THE AURORA HIGHLANDS SITE PLAN #16

AMENDMENTS

THE AURORA HIGHLANDS SITE PLAN #16
TITLE: L1.01 - XERIC LOT TYPICALS
DATE: JULY 24, 2024

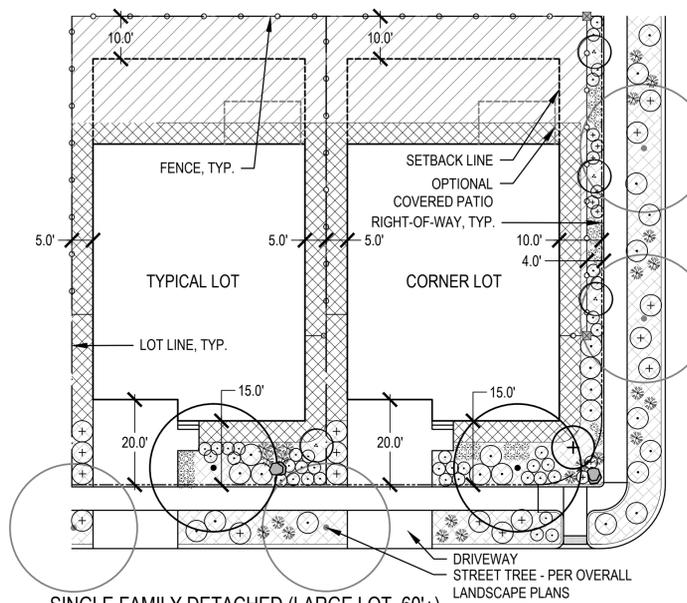
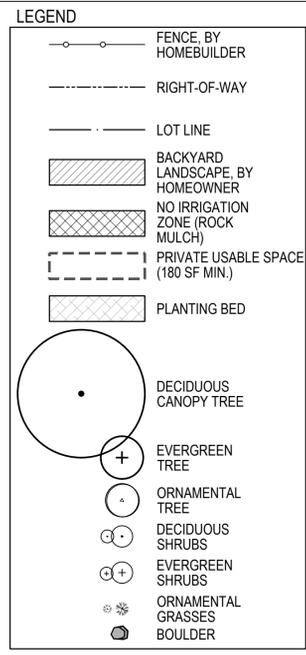
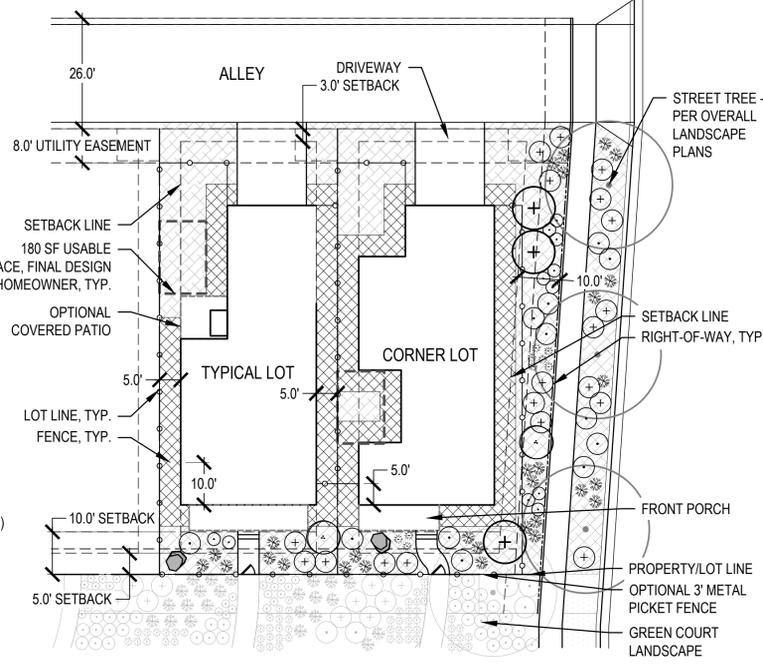
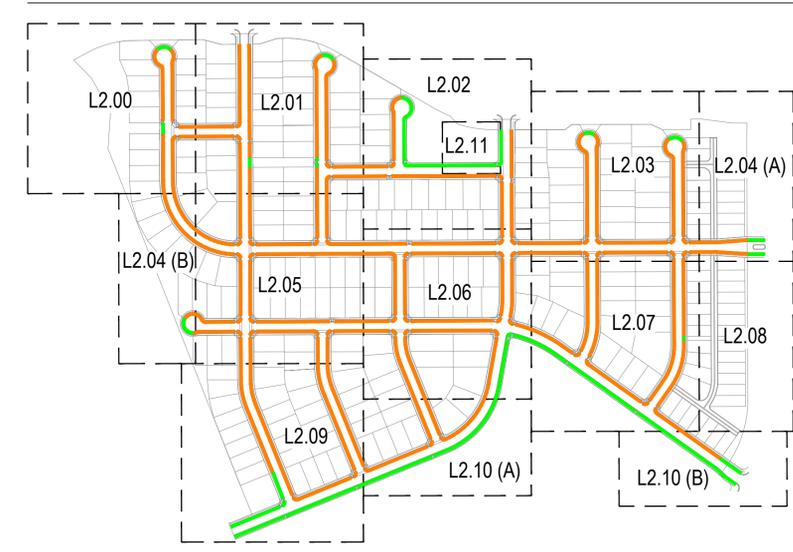
- 1 Mylar change to revise shelters, Detail 4/
Sheet L4.01 February 27, 2023
- 2 Revision to lot typical sheet (sheet 26) to
show requirements for a xeric lot typical and
curbside landscape. A key map was added
to the sheet to outline where the xeric
curbside landscape would occur.
